QUALITY ASSURANCE -- NON-CONFORMANCE REPORT

Report No: NCR-000458

Component: OBG Segment 5BW Floor Beam

Reference Description: Removal of a Floorbeam section and introducing additional weld splice at Floorbeam FB5A at PP33

Component: OBG Segment 5BW Floor Beam

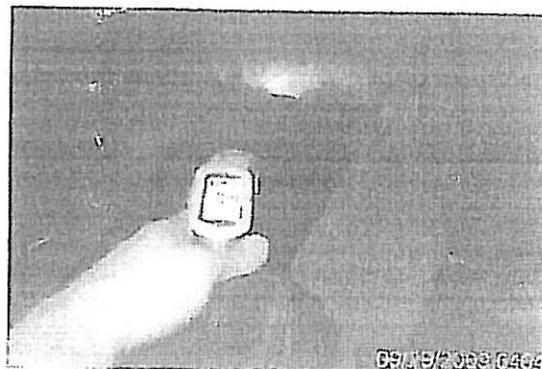
The Caltrans Quality Assurance (QA) Inspector observed that ZPMC personnel have removed a small section of plate from the lower Floor Beam and replaced this section with an unknown steel plate. During this process the contractor has removed the double-sided fillet welds and added a new un-approved complete joint penetration (CJP) weld without the Engineer's approval. Subsequently, the double-sided fillet weld joint between the new plate and the bottom panel was welded. This un-approved repair was performed at OBG Segment 5BW lower Floor Beam (FB5A) to Bottom Panel at panel point 33 between the 4th and 5th WT stiffeners from the Bikepath side.

Contractor submitted Material Traceability report for said plate. The plate has been tested and is in conformance with Contract specifications.
